STAFF RECOMMENDATION

NCPC File No. 6910

NATIONAL MALL AND MEMORIAL PARKS WAYFINDING AND SIGN PROGRAM - PEDESTRIAN GUIDES AND MAP KIOSKS

Submitted by the National Park Service

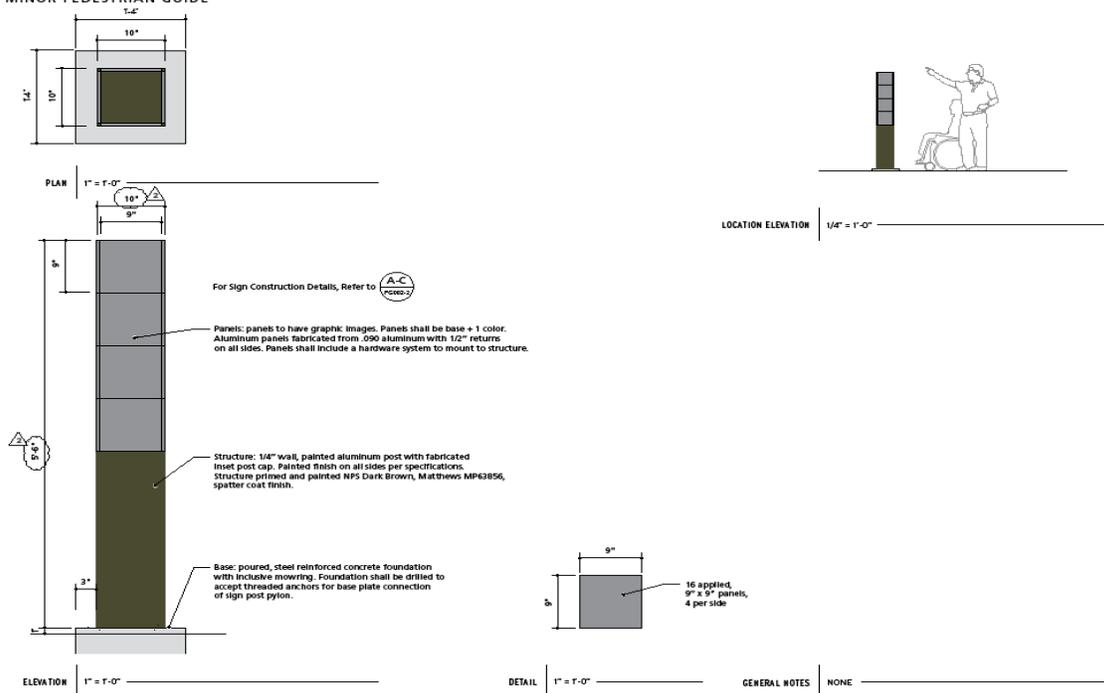
3. The "wayside" map kiosk has been enlarged in response to Commission guidance. The overall width of the wayside kiosk has been enlarged 12 inches in order to accommodate a larger map. The map kiosk, four feet in width when seen in the mock-up on site, has been enlarged to five feet in width. The map itself now measures approximately 17 ½ inches by 48 inches, an enlargement of approximately 30%.
